INTERNATIONAL SOLING CLASS

The following amendments to the Class Rules have been approved to be effective 1st March 2001.

Rule G.3.2.5

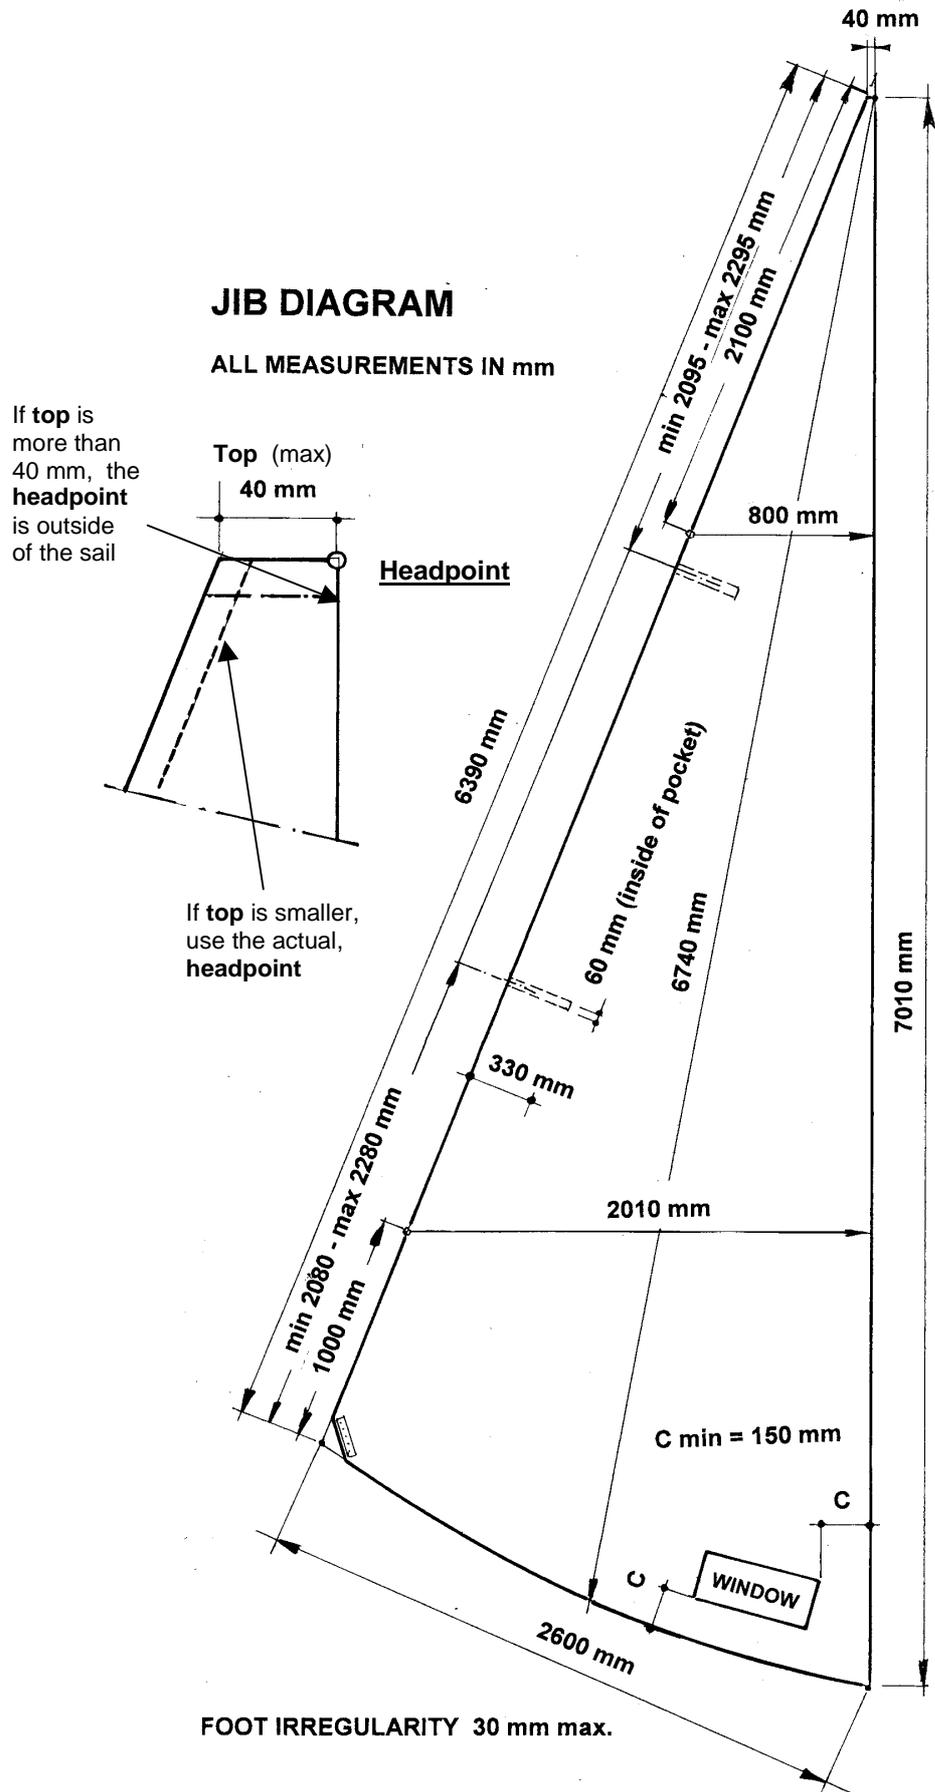
Amendment: Delete the current rule and replace with the following:

“Only four battens shall be permitted in the leech.

Batten pocket length:

Uppermost pocket:

not limited

Distance from headpoint to lower edge of batten pocket
at the luff (min.)

min. 1900 mm

Other pockets: Inside

max. 1200 mm

Batten pocket width: Inside

max. 60mm”
